APPLICATION NO.	FILING DATE	FIRST NAMED INVENTOR	ATTORNEY DOCKET NO.	CONFIRMATION NO.
10/781,613	02/18/2004	Thomas Alexander Horn	CM2603CQ	2691
27752 7590 06/29/2007 THE PROCTER & GAMBLE COMPANY INTELLECTUAL PROPERTY DIVISION - WEST BLDG.			EXAMINER	
			LAVINDER, JACK W	
WINTON HILL BUSINESS CENTER - BOX 412 6250 CENTER HILL AVENUE CINCINNATI, OH 45224		ART UNIT	PAPER NUMBER	
		3677		
			MAIL DATE	DELIVERY MODE
			06/29/2007	PAPER

DETAILED ACTION

Claim Rejections - 35 USC § 102

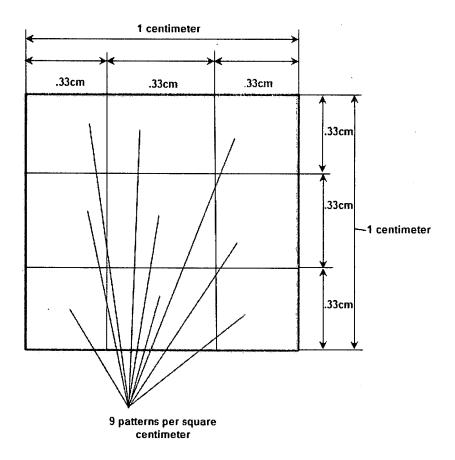
3. Applicant's arguments filed 4/5/2007 have been fully considered but they are not persuasive. The applicant argues that King makes no mention of a pattern of intersecting bond lines defining unbonded pattern element. King discloses a non-woven loop member (37) bonded to a backing member (34) via a criss-cross tessellated pattern of adhesive (figures 2 and 3) lines: continuous or non-continuous, straight or curved (column 8, lines 17-25). King also discloses the specific density of pattern elements being at least 3.2 pattern elements per square centimeter, i.e., at least 9 patterns per square centimeter, wherein each side of the pattern element is .3 centimeters long (column 8, lines 61-end and column 9, lines 1-2).

The applicant argues that the examiner incorrectly concludes that the claimed pattern elements of the present invention are the same as the extrapolation of the pattern side measurements of the King invention. The applicant fails to point out the errors in the examiner's conclusions. King discloses pattern elements defined by intersection, straight or curved bond lines (column 8, lines 17-25). King also discloses that each side of the pattern has a length from .3-1.3 cm (column 8, lines 61-end and column 9, lines 1-2), which tells one of skill in the art, the exact density of patterns on the web (see annotated figure showing the number of patterns per square centimeter).
